## COUNCIL ASSESSMENT BRIEFING REPORT TO PANEL SYDNEY SOUTH PLANNING PANEL

<b>PANEL REFERENCE &amp; DA NUMBER</b>	PPSSSH-135– DA2023/0104 – PAN-296783
<b>PROPOSAL</b>	Construction of a 12 storey residential flat building containing 100 apartments with 3 levels of basement parking containing 104 car spaces, alterations and additions to the heritage dwelling and adaptive re-use as a cafe, landscaping, site works and lot consolidation.
<b>ADDRESS</b>	2-4 Victoria Street, Kogarah
<b>APPLICANT</b>	Mr George O'Donovan - The Hadd Group Pty Ltd
<b>OWNER</b>	Eddy Haddad
<b>DA LODGEMENT DATE</b>	13 June 2023
<b>APPLICATION TYPE</b>	Development Application
<b>REGIONALLY SIGNIFICANT CRITERIA</b>	Section 2.19(1) and Clause 2 of Schedule 6 of <i>State Environmental Planning Policy (Planning Systems) 2021</i> declares the proposal regionally significant development as: The development has a capital investment value of more than \$30 million.
<b>CIV</b>	\$30,120,000 (excluding GST) (excluding GST)

Panel Assessment Briefing Report – RFB & Adaptive re-use of heritage cottage - 6/11/2023  
2-4 Victoria St, Kogarah

**Figure 7 – Northern Elevation showing the heritage item with RFB behind when viewed from Victoria Street. Also of note is the lack of building articulation.**

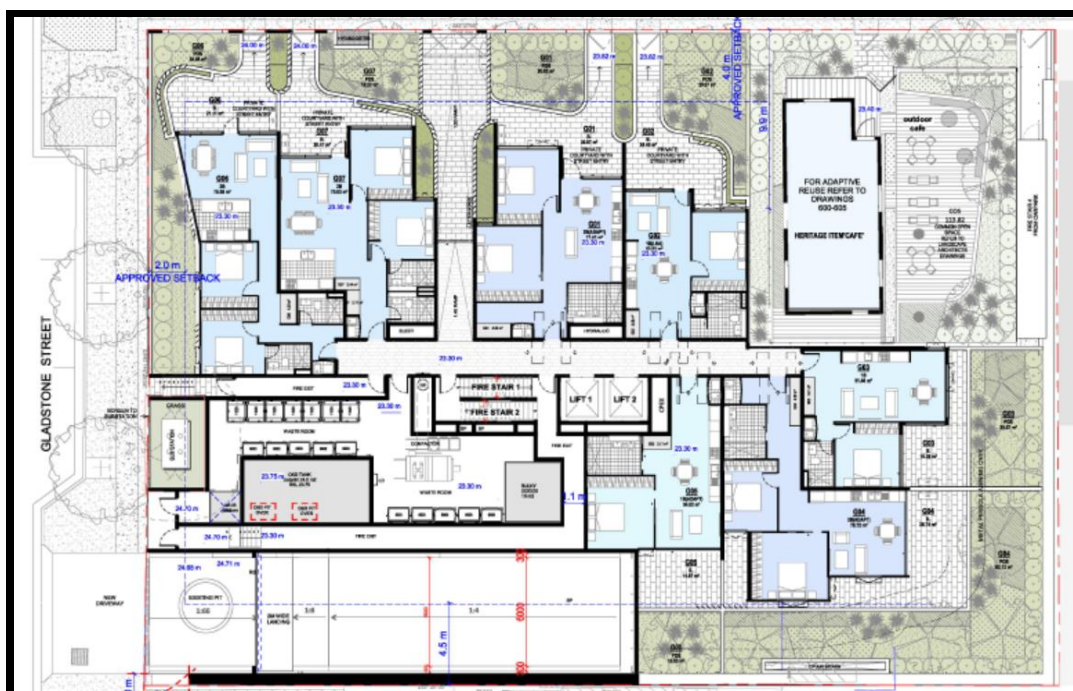
Although the built form above the 4th storey incorporates balconies, the facades predominantly maintain the building edge and does not provide any substantial massing variation except for the northern façade emphasising the box like bulky appearance. A significant eye level southern elevation is dominated by solid blank driveway wall. The proposed bulk and scale are considered excessive and not supported.

The design should also present a podium and tower typology with preferably a 3 storey podium around the existing heritage Cottage increasing to 4 storeys. The tower above should be setback minimum 3m to provide consistent architectural language and variation in the built form.

**Figure 8 – Eastern Elevation detail showing the heritage item with RFB behind and over hanging. Note the RFB sits proud of the heritage item on the Gladstone Street corner.**

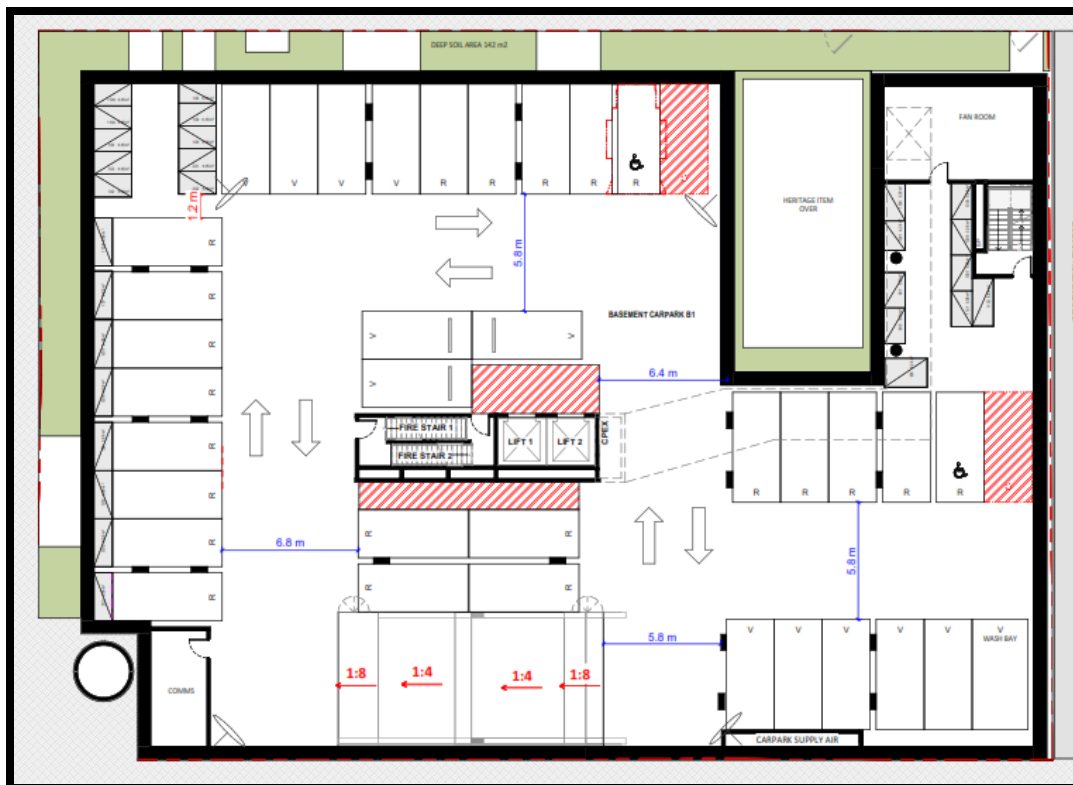
The subject site contains a single storey cottage (2 Victoria Street) and is heritage listed due to its significance. The Cottage is proposed to be retained and potentially converted to a café with outdoor dining to the north-east (4 Victoria Street). The 5th storey and above of the proposed apartment building extends above/over the heritage item with this built form supported by two columns (Refer Figure 3).

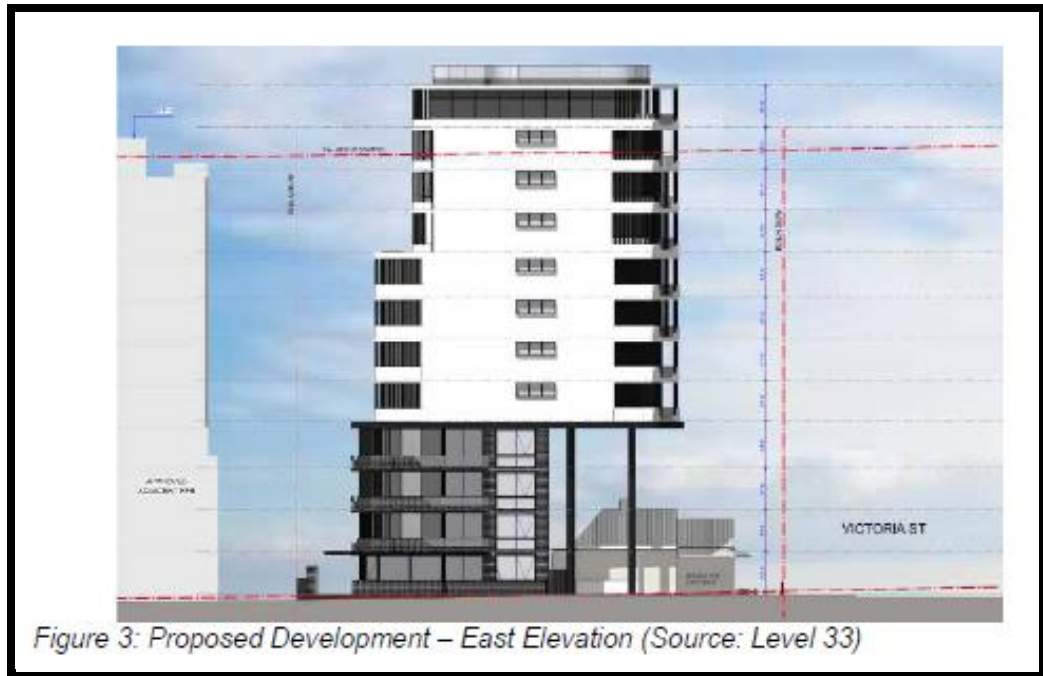
On the 5th storey and above, the double loaded corridor, which is 23m long provides access to 9 apartments on each storey and has no access to natural light and ventilation. This does not comply with ADG Objective 4F-1. The total number of apartments sharing a single lift is 40. The proposal has 100 apartments sharing 2 lifts. This is not consistent with the ADG objective.

The proposed corridors do not provide articulation or opportunity for casual social interaction or incidental spaces for seating. The proposal does not comply with ADG Objective 4F-2.

The design should be amended to provide daylight and natural ventilation to all corridor / common circulation spaces. Although the corridor width may comply with the NCC/AS, a wider corridor is preferred to allow for comfortable movement. For the proposal to comply with Objective 4F-1, more than 2 lifts are required to service the proposed 100 apartments, especially given the solar access and natural ventilation non-compliance of the proposal.

The corridor / common circulation space should also be designed to provide incidental spaces for casual social interaction. Relocating the waste room / bulky good to the basement should be considered to allow for the redesign of the corridor/common circulation space on the ground level.

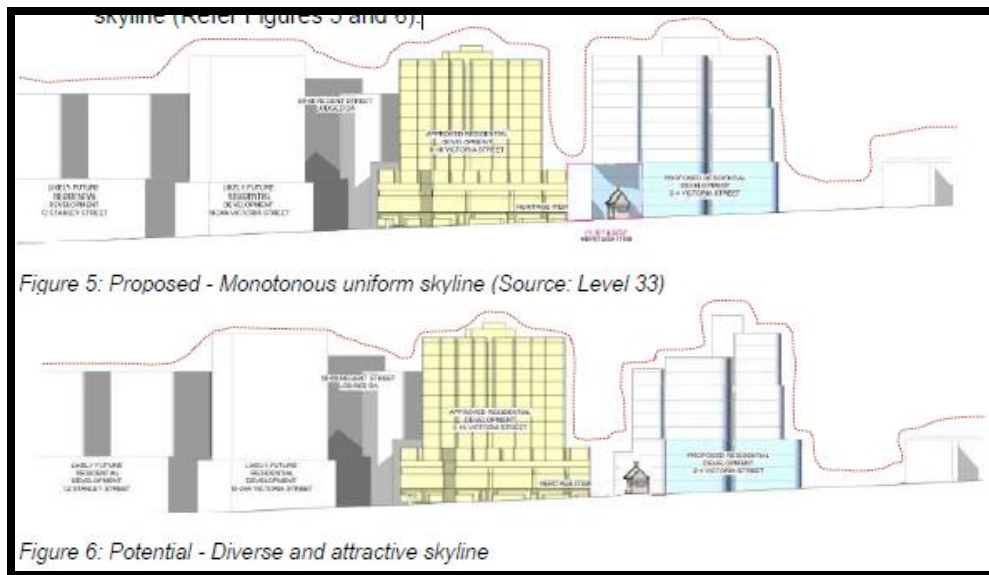
In spite of the staggered Victoria Street setback/façade, given the lack of appropriate side and upper level setbacks, the proposal presents as a monolithic block with no variation in massing composition (Refer Figure 4). The proposed building typology is not consistent with the emerging streetscape and not compliant with the GRDCP requirements.

The proposed maximum building height of 41.6m (to lift overrun) exceeds the permissible building height of 33m by 8.6m. In addition, the proposed 4.29 :1 FSR exceeds the permissible 4 :1 FSR.

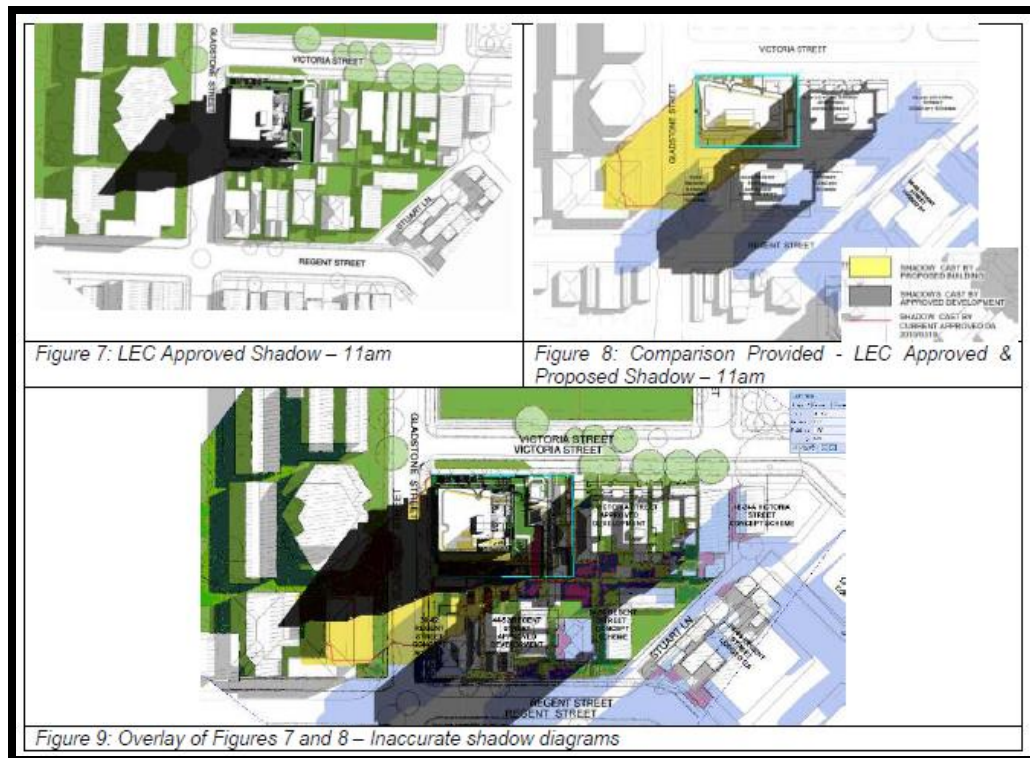
Objective 4A-1 of the ADG requires minimum 70% of the living rooms and private open spaces (POS) of apartments in a building to receive a minimum 2 hours direct sunlight between 9am and 3pm at mid winter. A maximum of 15% of apartments could receive no direct sunlight. The proposal includes a total of 100 apartments of which minimum 70 apartments and their POSs are required to comply with the ADG.

Additional and accurate information should be provided to ascertain compliance of the proposal with the solar access requirements. It is unlikely that the proposal will comply with the solar access requirements.

Shadow diagrams provided are incorrect. As an example, a comparison between the LEC approved development 11am shadow and the 11am comparison provided with the current application is provided below (Refer Figures 7 and 8). An overlay of the two is included to illustrate the actual increase in overshadowing (Refer Figure 9).

The shadow of the LEC approved development illustrated in the comparison provided (Refer Figure 8 - Red outline) has been significantly augmented and incorrect. The SEE provided states that *there is no significant difference in shadow within the context of the site which arises from the proposed variation which would warrant strict compliance in this instance*. However, this is incorrect. There is a significant difference in the extend of the shadow cast by the LEC approved development and the proposal with its excessive bulk and scale (Refer Figures 7, 8 and 9).

- Clarification on Drawing N0. 302 - Solar Compliance, Issue A dated 8 January 2023, which has apartments on Level 11B facing south as compliant.
- Given the depth and the existing heritage Cottage to the north, it is unlikely that Unit G.03, POS will receive the required direct solar access.
- Similarly, given the built form above the heritage Cottage, solar access to apartments 103, 203 and 303 and their POSs is a concern.
- Given the depth of the balconies in the northeast corner, solar access to apartments 404, 504, 604, 704, 804, 904 and 1004 is of concern.
- Detail solar analysis should be provided including elevational shadows and internal views taking the context into consideration.
